ENVIRONMENTAL REVIEW COMMITTEE REPORT AND ADMINISTRATIVE SHORT PLAT REPORT & DECISION

ERC MEETING DATE:	October 11, 2010		
Project Name:	West Pacific Short Plat		
Owner:	West Pacific International, LLC; 4957 Lakemont Blvd SE, Suite C4-322; Bellevue, WA 98006		
Applicant:	Tom Redding, Encompass Engineering & Surveying; 165 Juniper Street, Suite 201; Issaquah, WA 98027		
Contact:	Tom Redding, Encompass Engineering & Surveying; 165 Juniper Street, Suite 201; Issaquah, WA 98027		
File Number:	LUA10-064, SHPL-A, ECF		
Project Manager:	Gerald Wasser, Associate Planner		
Project Summary:	The applicant requests Environmental (SEPA) Review and approval of an Administrative Short Plat for a 2-lot subdivision of a 22,500 square foot parcel (APN 008800-0495) in the Residential - 8 dwelling units per acre (R-8) zone. Density is proposed to be 5.63 dwelling units per acre. Proposed Lot 1 would be 5,100 square feet and has an existing residence (to remain). Proposed Lot 2 would be 17,400 square feet and contains a 6,238 square foot Category 2 wetland. The applicant is proposing buffer averaging of the required 50-foot wetland buffer to provide for a desired building envelope on proposed Lot 2. T

WEST PACIFIC SHORT PLAT
SITE PLAN

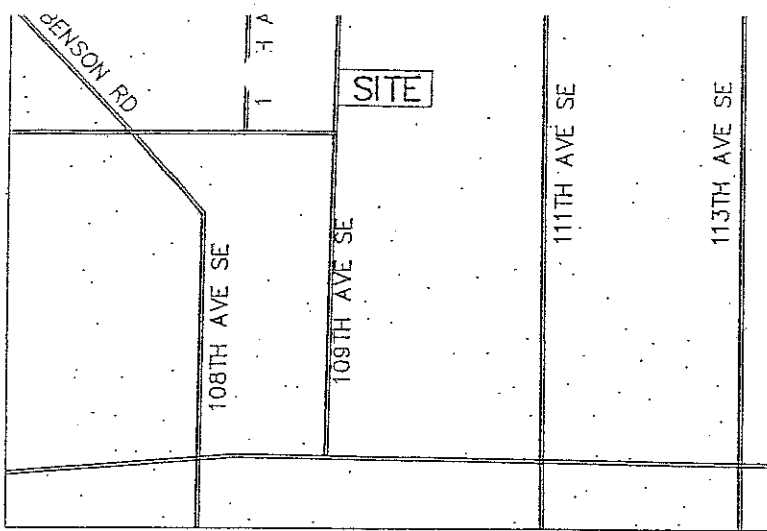
Remove everything from the "LEGEND" and "TREE LEGEND" blocks. These items do not directly impact the subdivision.

Do not include the "OWNER/DEVELOPER", "ENGINEER/SURVEYOR", "DATUM", "VERTICAL CONTROL", "STREET ADDRESS", "ZONING", "PROPOSED DENSITY" and "PERMITTED DENSITY" blocks on the final short plat submittal. These items also do not directly impact the subdivision.

On the final short plat submittal, remove from the drawing all references to utility facilities, topog lines, decks, trees, concrete walk, concrete vault and other items not directly impacting the subdivision.

Remove the building setbacks lines from the proposed lots. Setbacks will be determined at the time that building permits are issued.

Remove the King County Tax Lot Nos. from the short plat submittal.

Include a north arrow with the "VICINITY MAP".
